CITY OF MIAMI
Capital Improvements Program

Williams Park Community Center, B-75991A

ADDENDUM NO. 7

February 25, 2010

ADDENDUM 7
WILLIAMS PARK COMMUNITY CENTER
ALLOWANCE ITEM # 15 -
MCT FLOOR PATTERNS

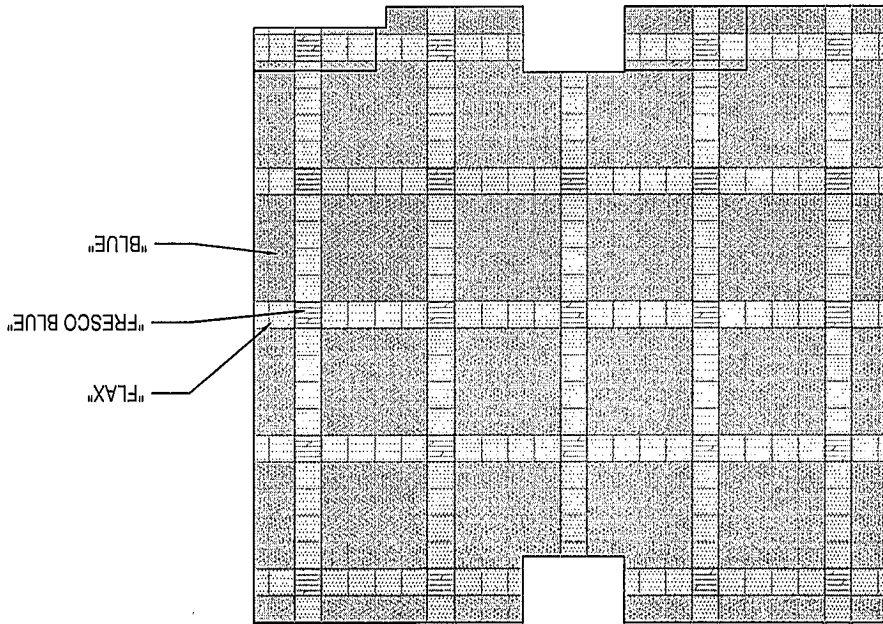
14	\$8,000	Upgrade Pool Bldg restrooms - Remove and replace all toilets (Quantity 6), urinals (Quantity 2) and sinks (Quantity 2); paint all walls and ceiling; install epoxy flooring.
15	\$9,000	Upgrade finishes in Community Center - Substitute all 12"x12" and 24"x24" rectified ceramic floor tile with 12"x24" tiles installed in running bond pattern. Install MCT in Room 107, 108 and 114 in decorative patterns shown on attached plan. Two paint colors in Rooms 101, 102, 106, 109 and 114. At all locations where rubber base is indicated use 5 1/2" H x 1/8" thick Pinnacle Plus sculpted rubber base by Roppe, profile # 15.

ROOMS 107 AND 108
 ALL COLORS PER FORBO MCT SERIES

MULTIPURPOSE ROOM 114
 ALL COLORS PER FORBO MCT SERIES
